Subject: Virgil C. Summer Nuclear Station  
Docket No. 50/395  
Operating License No. NPF-12  
Equipment Qualification

In a recent telephone conversation with members of the NRC Staff, several questions were posed regarding D. G. O'Brien Qualification Report ER-307 for the triaxial plugs for containment penetrations at South Carolina Electric and Gas Company's Virgil C. Summer Nuclear Station. This letter forwards the answers to the questions and explains the process by which the qualification documentation has been accepted.

Subject: Your letter of March 26, 1982  
NE File: 16.210

FIG 1

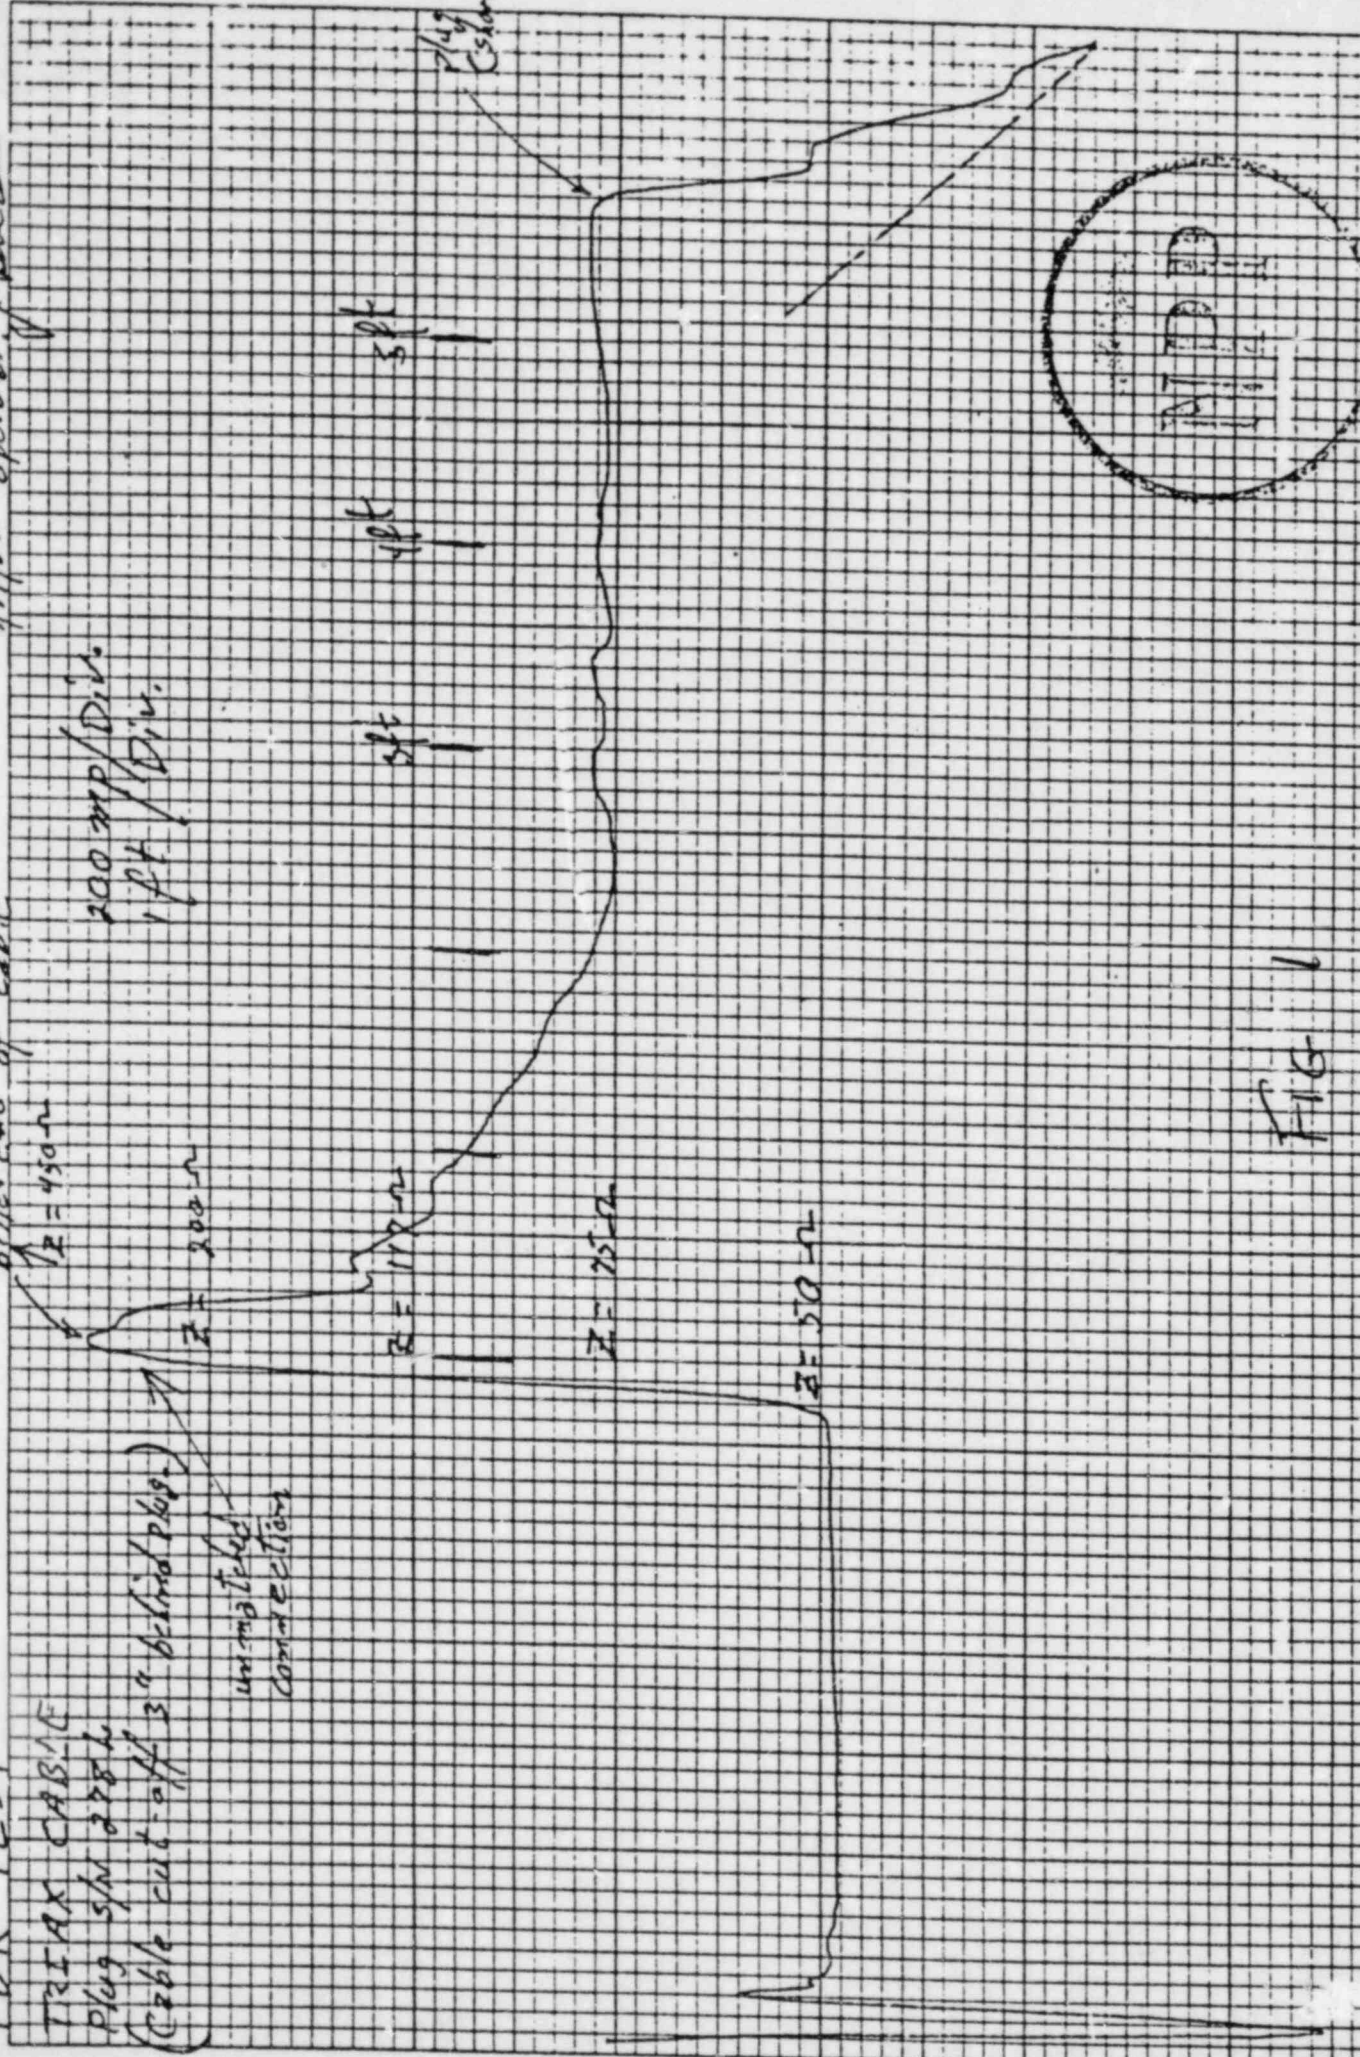
Item 1 As stated in the report, the outside containment cable was responsible for the insulation resistance and dielectric strength problems. A TDR (Time Domain Reflectometry) investigation was applied to the outboard cable. A plot of the cable condition is presented as Fig. 1 of this letter. As indicated, the cable was cut off approximately 3 inches behind the plug and terminated in a "short." The signal was then applied at the better end of the cable between the center conductor and inner shield. The plot does not conclusively indicate any major discontinuity that would justify the low IR and withstanding voltage.

FIG 2

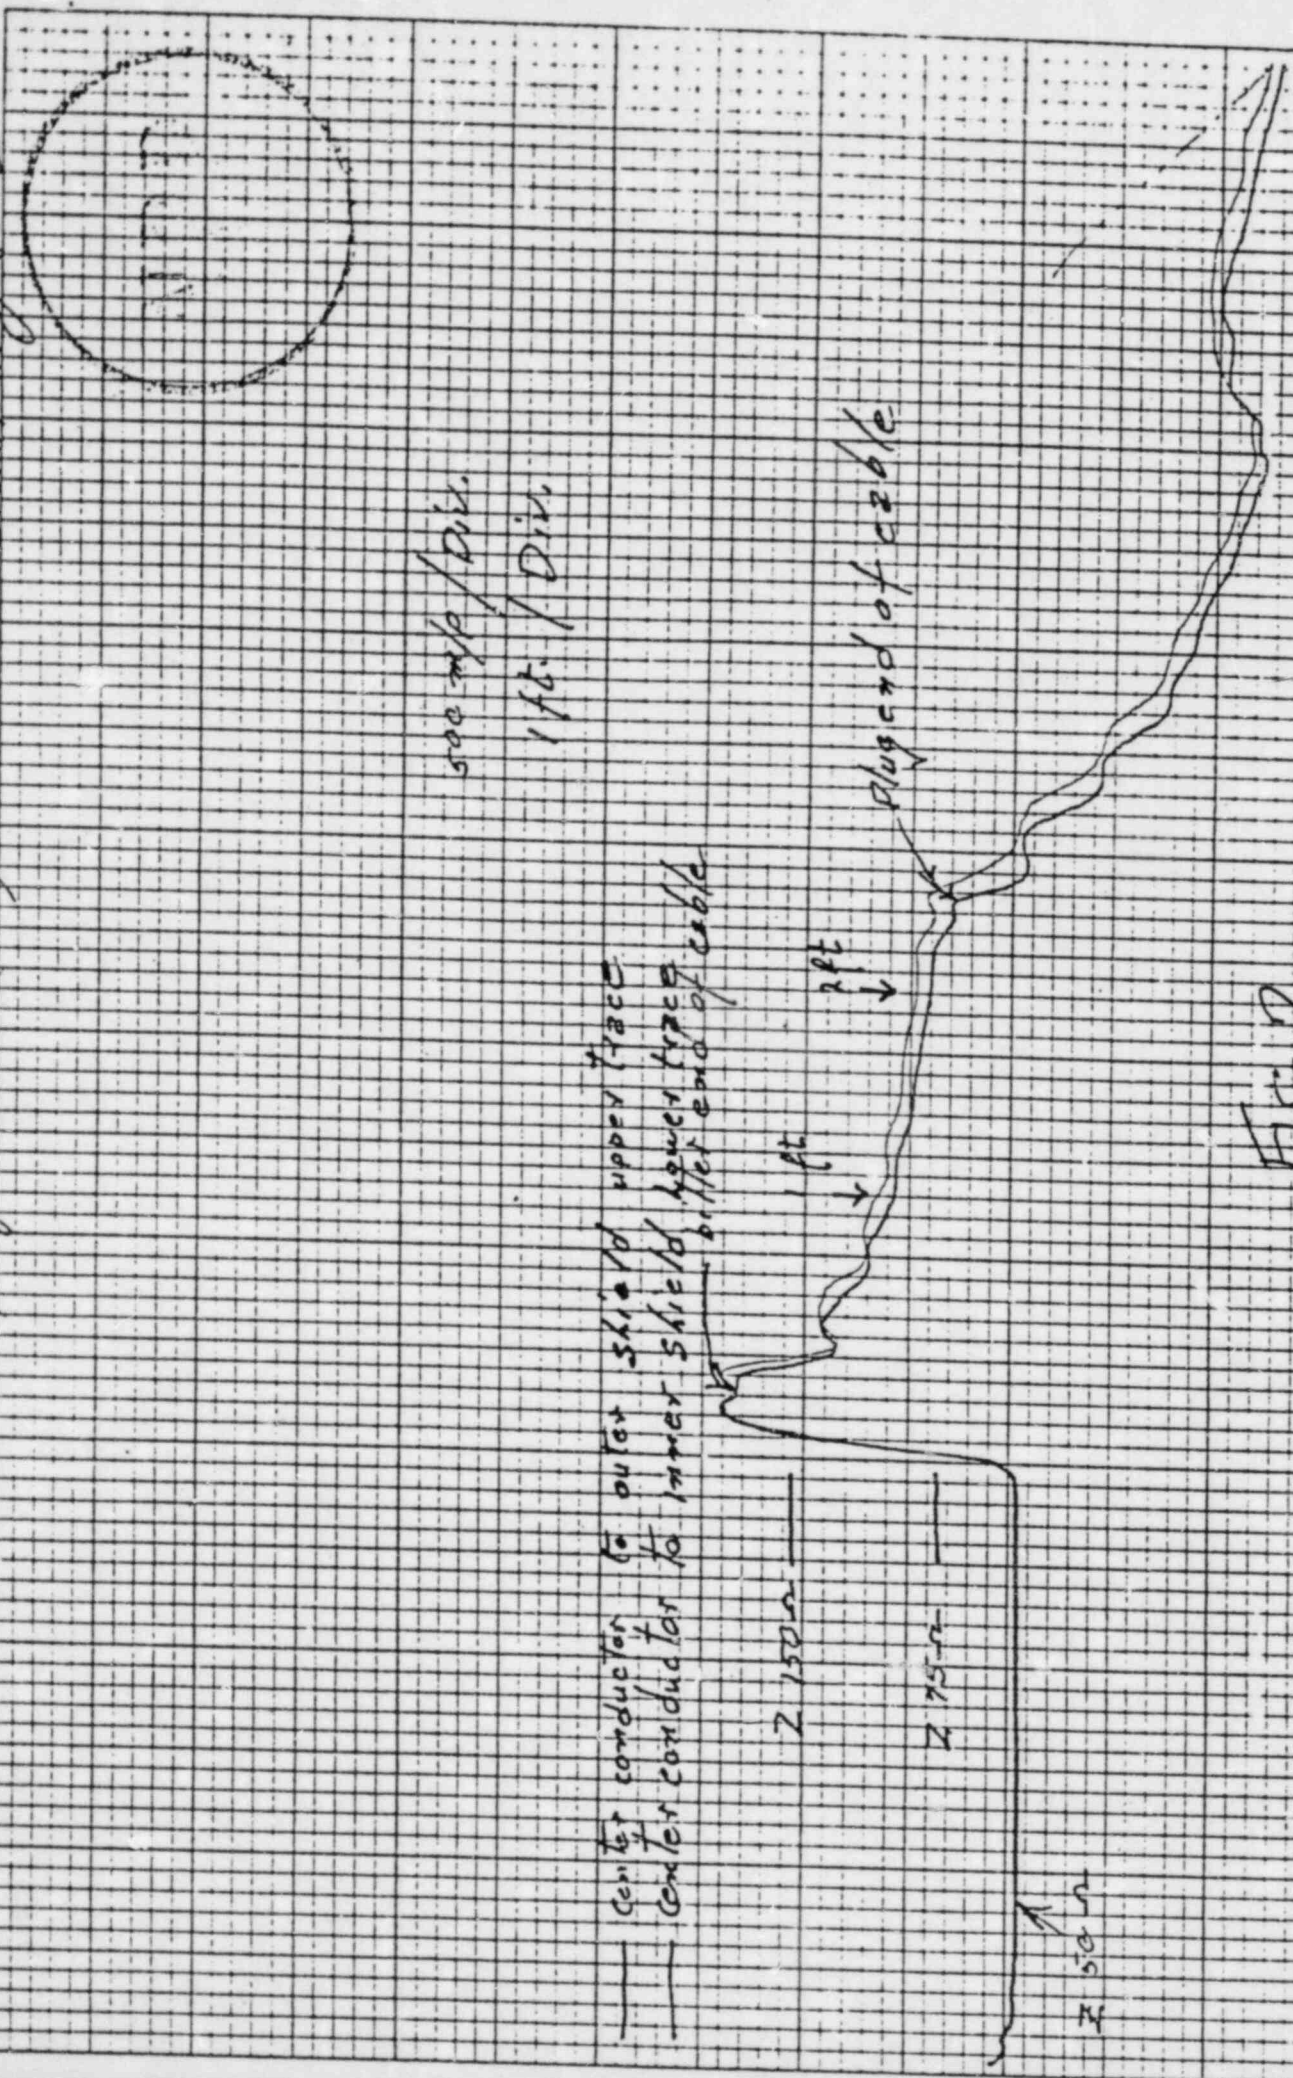
The same investigative steps were applied to the inner cable assembly. Those results are recorded as Fig. 2 and Pages 3-6. The TDR investigation was more difficult to conduct because the problem was occurring between shields. By comparing the traces, center conductor to each shield individually, we conclude that where the traces touch are points of possible cable non-conformance.
